# SERVICE LETTER

No. 186

SUBJECT: Clearance between the Engine Mount and the Exhaust Tail Pipe and  
Clearance in the Nose Wheel Steering Mechanism

MODELS AFFECTED: All Model PA-22 Airplanes

Sketch for Service Letter No. 186

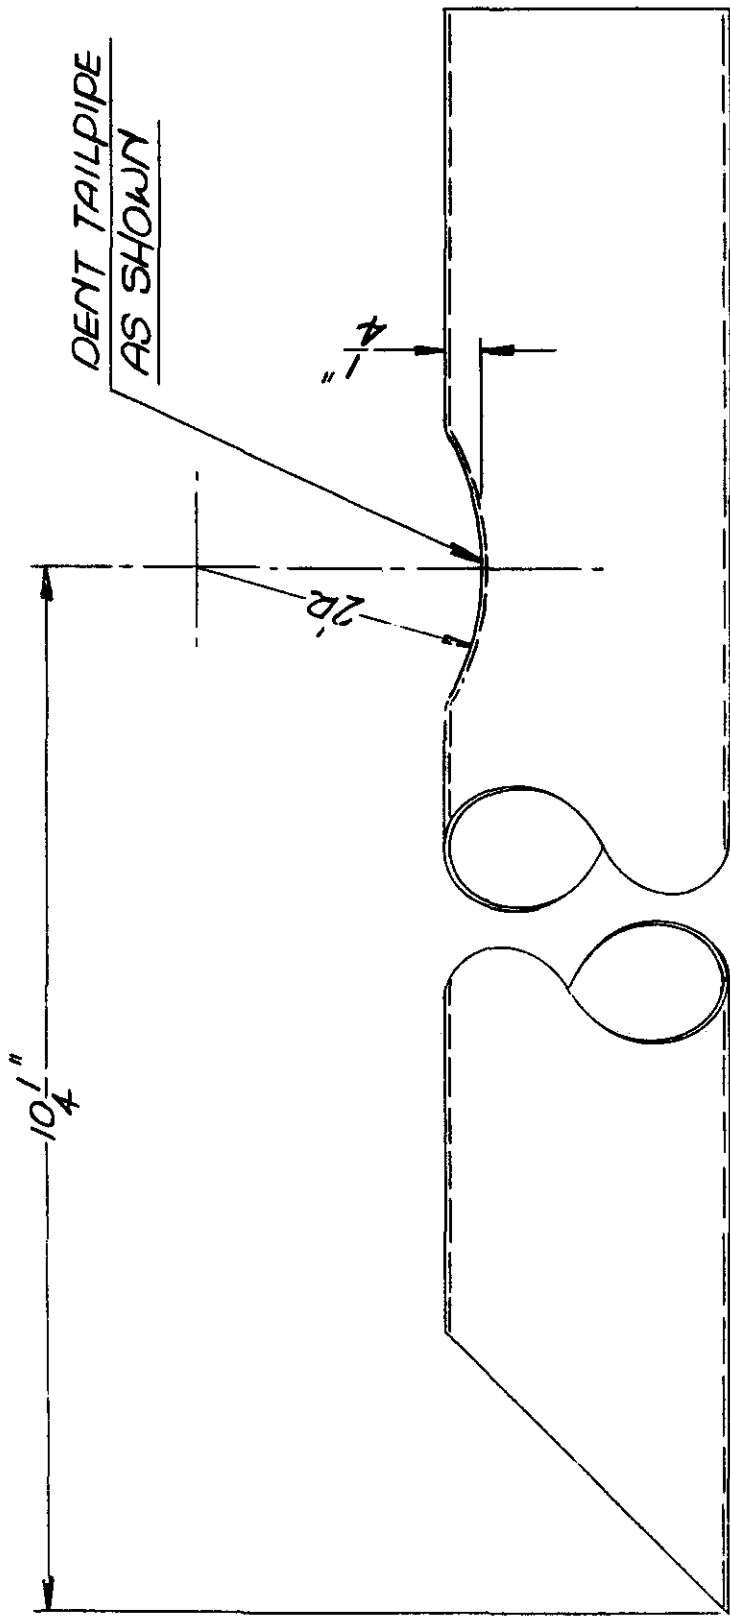
It has been brought to our attention that the clearance between the engine mount and the tail pipe on the subject model airplane is not adequate and in some cases the tail pipe has rubbed the diagonal motor mount tube causing the tube to become somewhat grooved, due to the rubbing and scrubbing action of the tail pipe.

It is requested that an inspection be conducted on all model PA-22 airplanes to ascertain whether or not this condition exists. If at the present time there is no sign of the tail pipe rubbing the motor mount tube it will not be necessary to make any adjustments, however if there are indications that this rubbing action has been taking place then it will be necessary to move the tail pipe location forward, by means of changing or adjusting the tail pipe braces. The clearance between the motor mount and the tail pipe brace should be approximately 3/8 inch. If there has been damage to the motor mount tube in that area it will be necessary to weld an outside sleeve reinforcement in accordance to C. A. A. Manual 18.

When moving the tail pipe forward to provide adequate clearance, there may be slight confliction between the tail pipe and the bottom engine cowl, in which event it will be necessary to cut out a small portion of the cowl.

In the event it is impossible to obtain the proper clearance then the tail pipe should be modified in accordance with the attached sketch.

It has been reported that there have been cases of interference between the cross-over exhaust stacks and the nose wheel steering rod ends. We suggest that you investigate the possibility of this condition existing in your airplane and take corrective action if necessary. Proper clearances can be obtained by denting the exhaust stack tubes at the points of contact by using the same steps and dimensions as shown in the tail pipe sketch.
